Proposed Project Modifications

V58

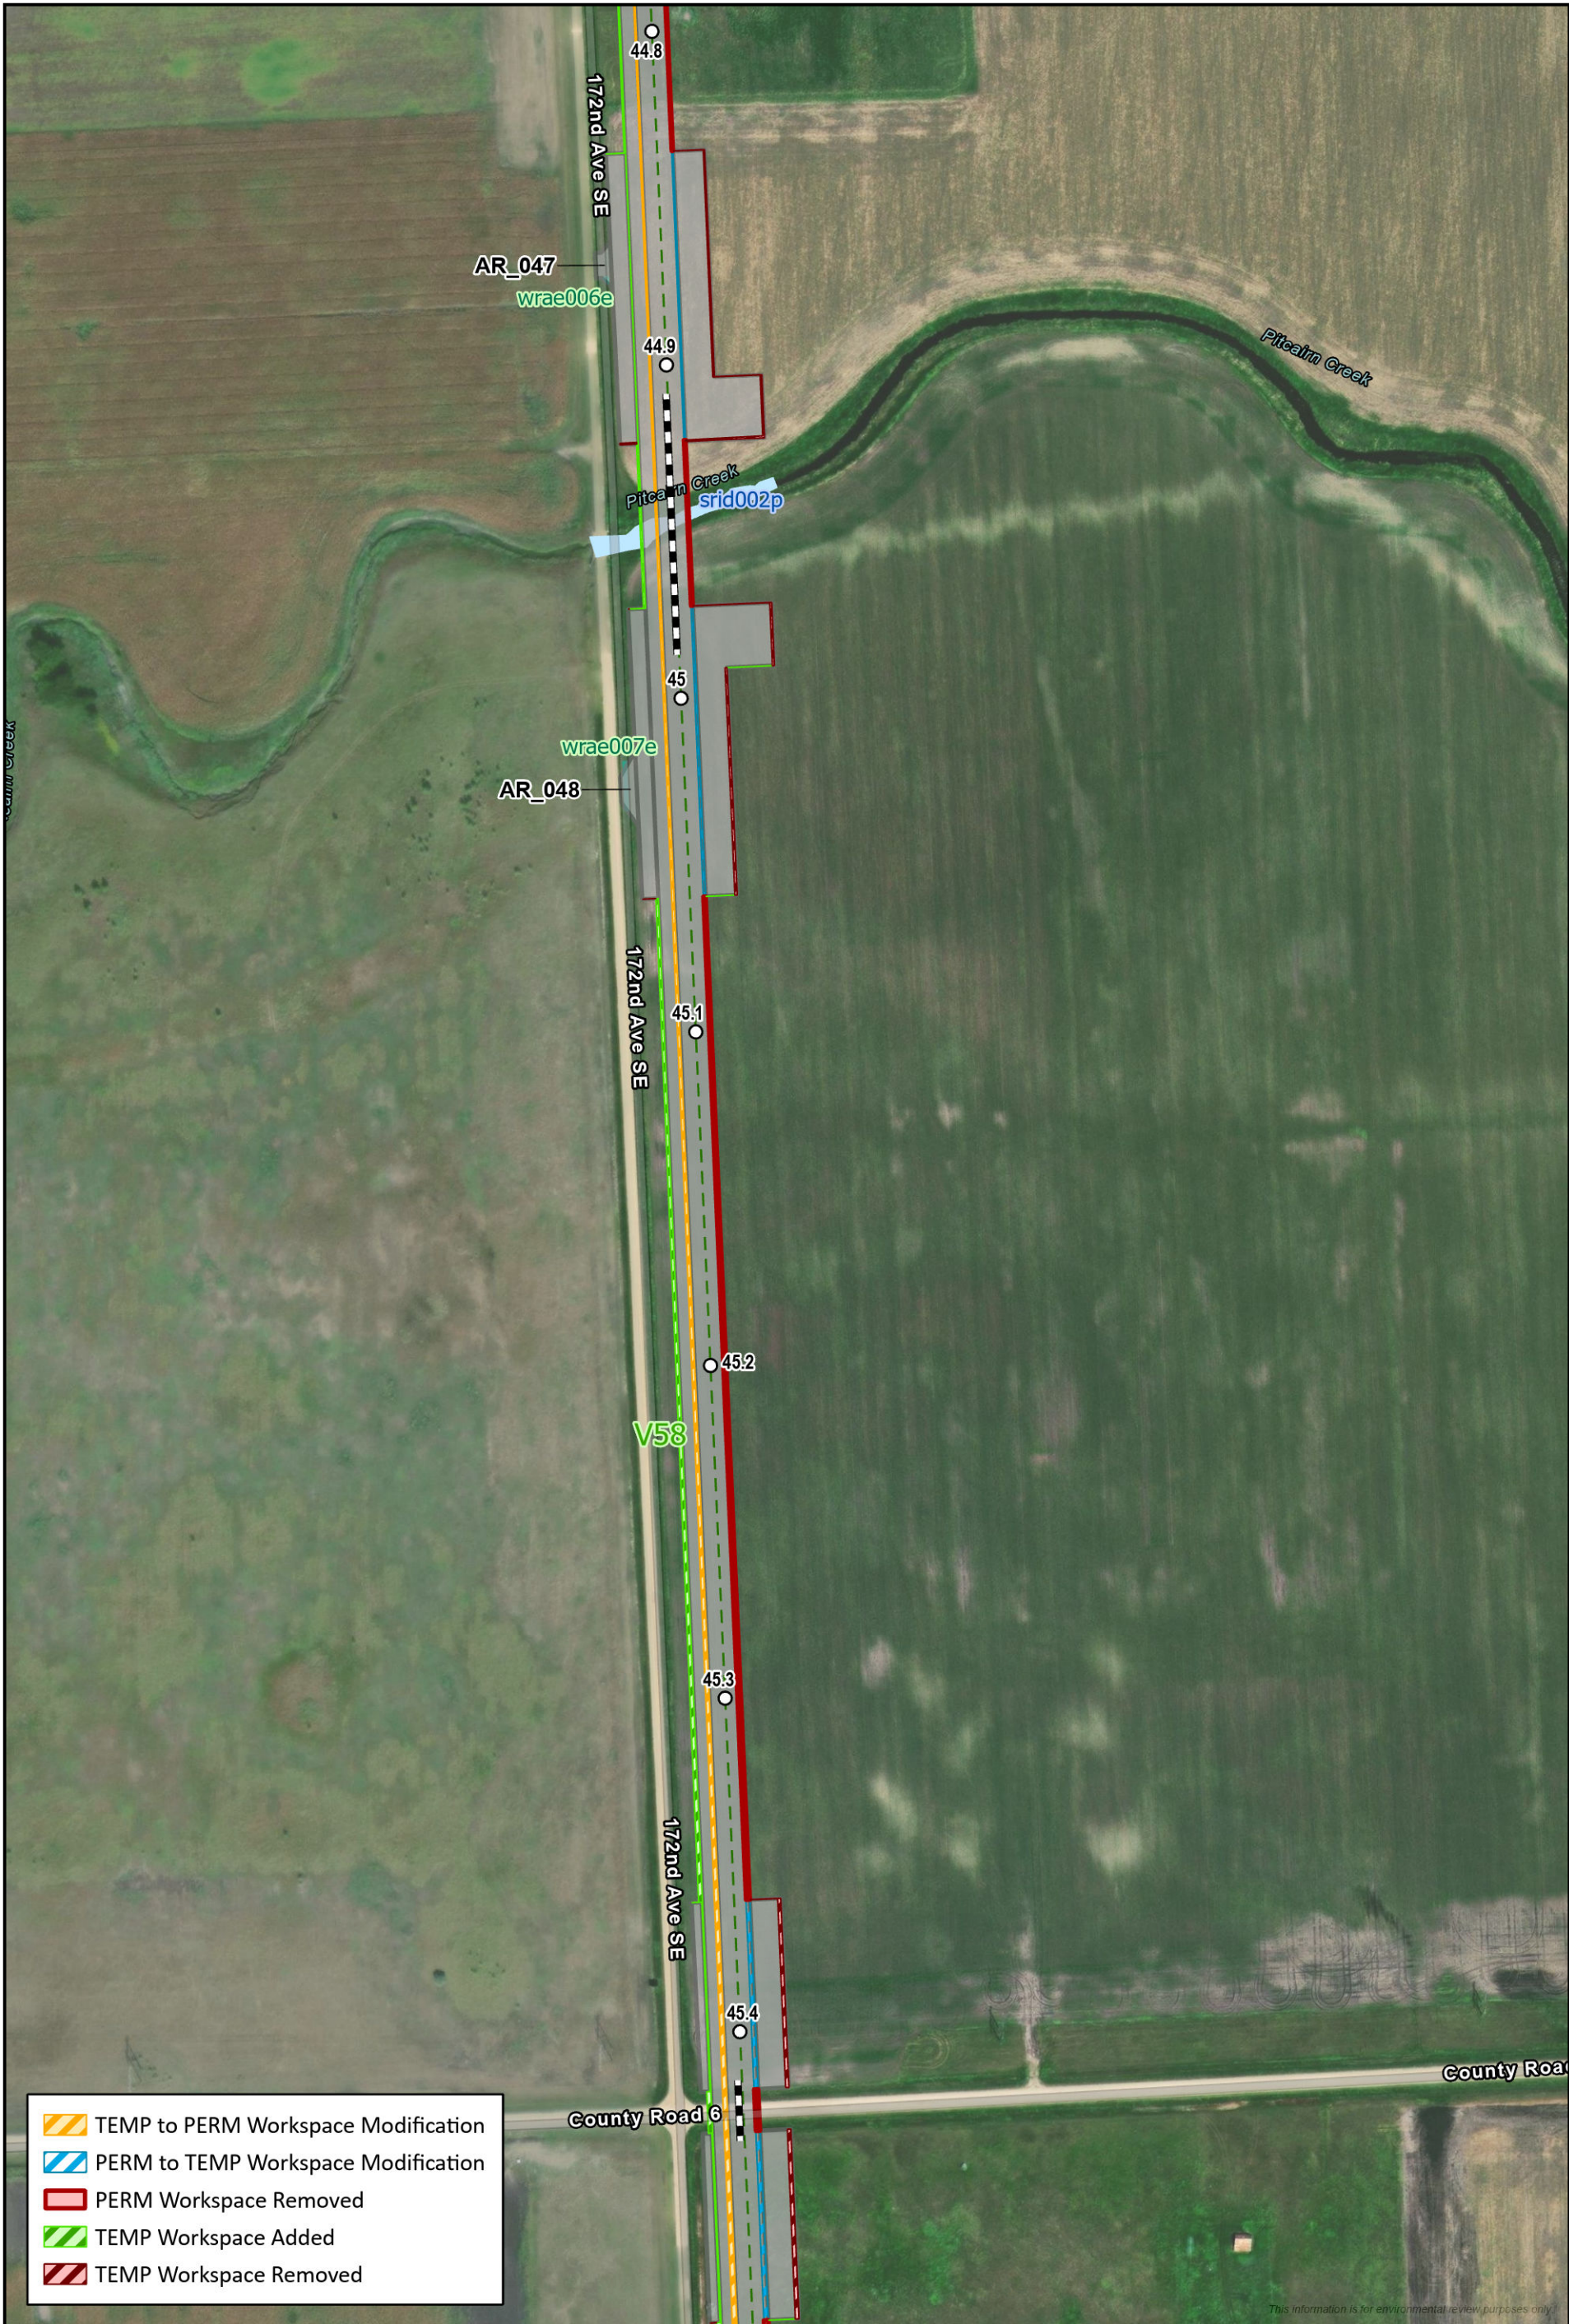
- TEMP to PERM Workspace Modification
- PERM to TEMP Workspace Modification
- PERM Workspace Removed
- TEMP Workspace Added
- TEMP Workspace Removed
